DCWG Meeting Tier 1 Enhancement Effort – Tier 1, Section 2.6

January 20, 2011
Mitsubishi Nuclear Energy Systems, Inc.

**APWR DCD Tier 1
Bases for "Generic" ITAAC Changes Contained in Tier 1, Section 2.6**

Tier 1 Changes Explanation/Basis Document
Tier 1, Section 2.6.1

Figure 2.6.3-1 I&C Power Supply Systems

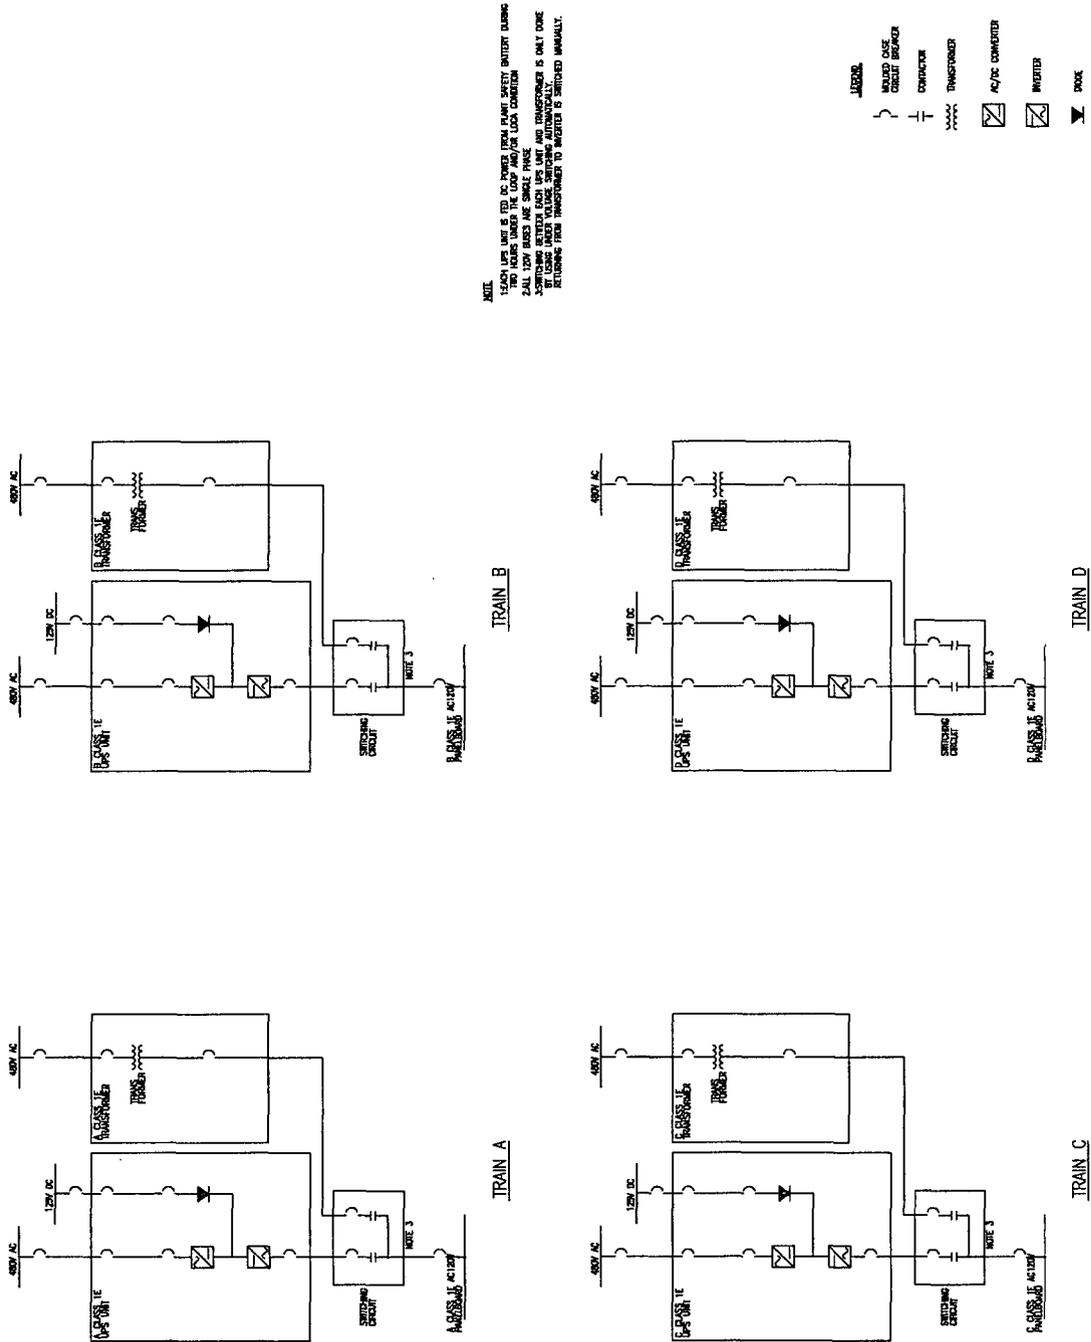
Item No.	Explanation/Basis for Change
	Changes noted on figure to show a bypass step down transformer for the alternate source. Change made to provide consistency to Tier 2.
